**Submission of Further Information (FI)**

**Temporary Animal Boarding Establishment with Ancillary Facilities and associated  
Filling of Land for a period of 5 years in "Agriculture" Zone,  
Lot Nos. 1493 (Part) and 1500 (Part) in D. D. 107 and Adjoining  
Government Land, Yuen Long, New Territories  
(Application No. A/YL-KTN/1177)**

**Further Information for Planning Application No. A/YL-KTN/1177****Response-to-Comments****Comments from Drainage Services Department**

Plan 6.2c  
( P 23044 )

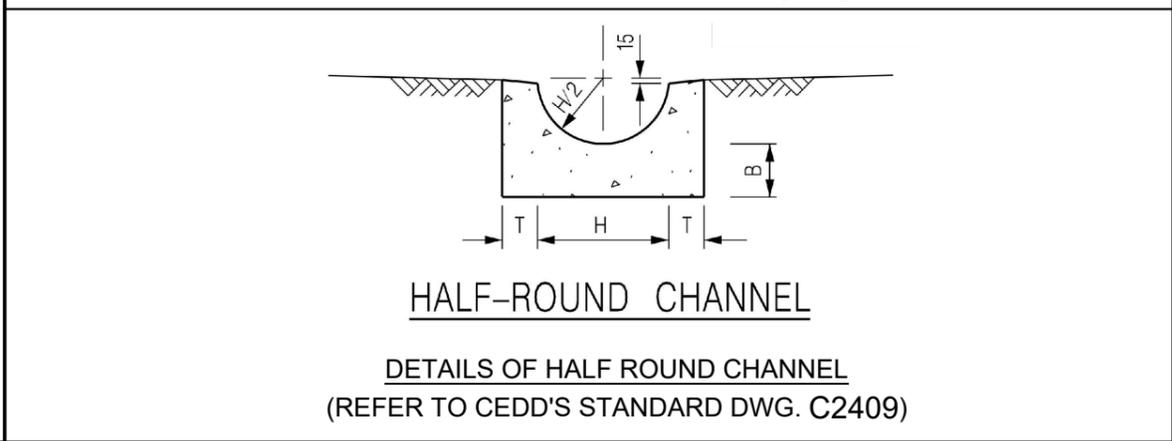
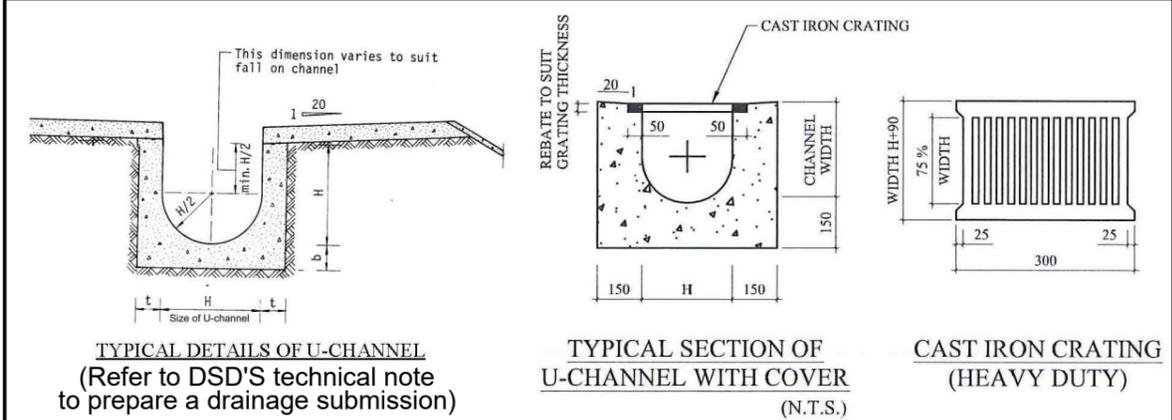
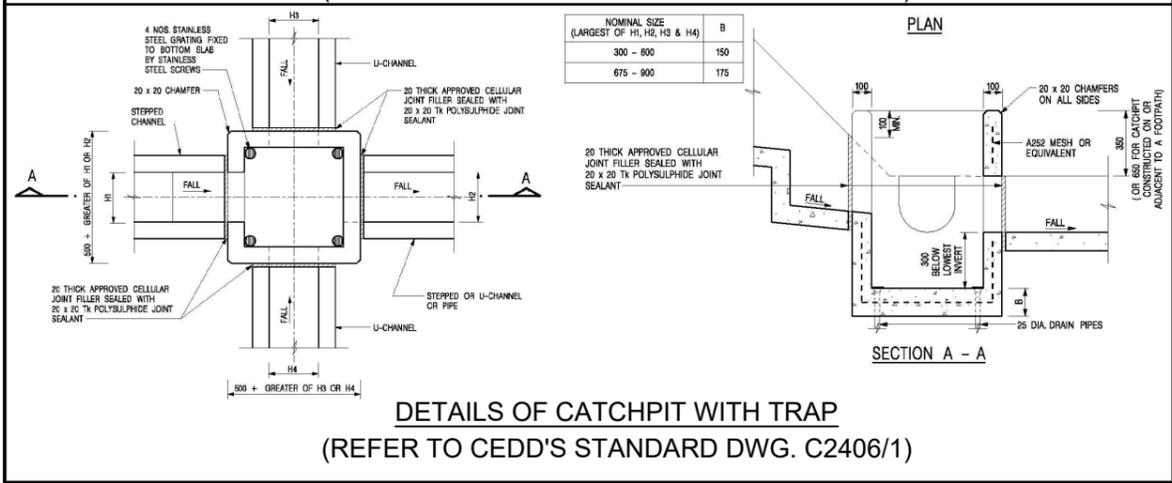
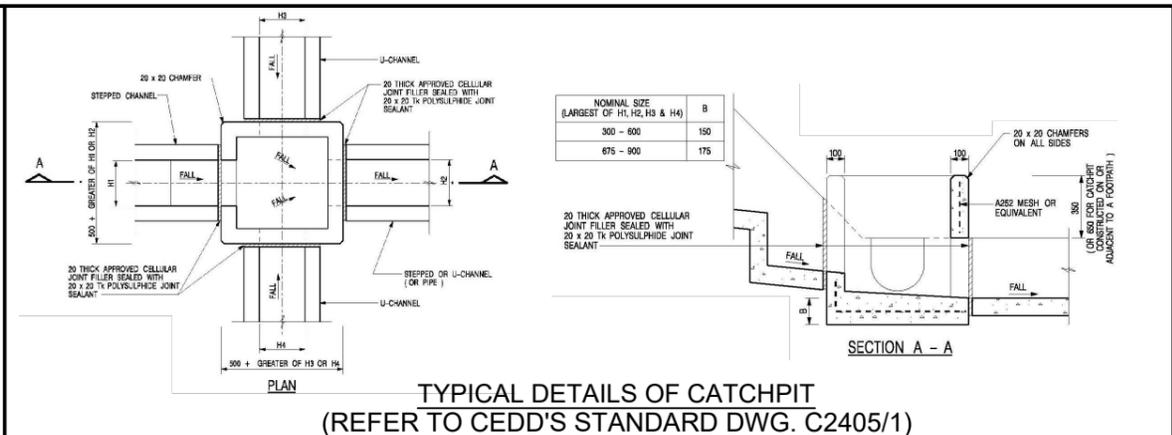
<b>I.</b>	<b>Comments</b>	<b>Responses</b>
1.	Section B - Please review the adjacent site ground levels. According to our record, the adjacent road level is higher than the application site, external catchment area should be considered. Please update the section and calculations if necessary.	External catchment area of the adjacent road is included. Please refer to updated Drainage Proposal (Plan 6.1b and Plan 6.2c) and Hydraulic Calculations for details.
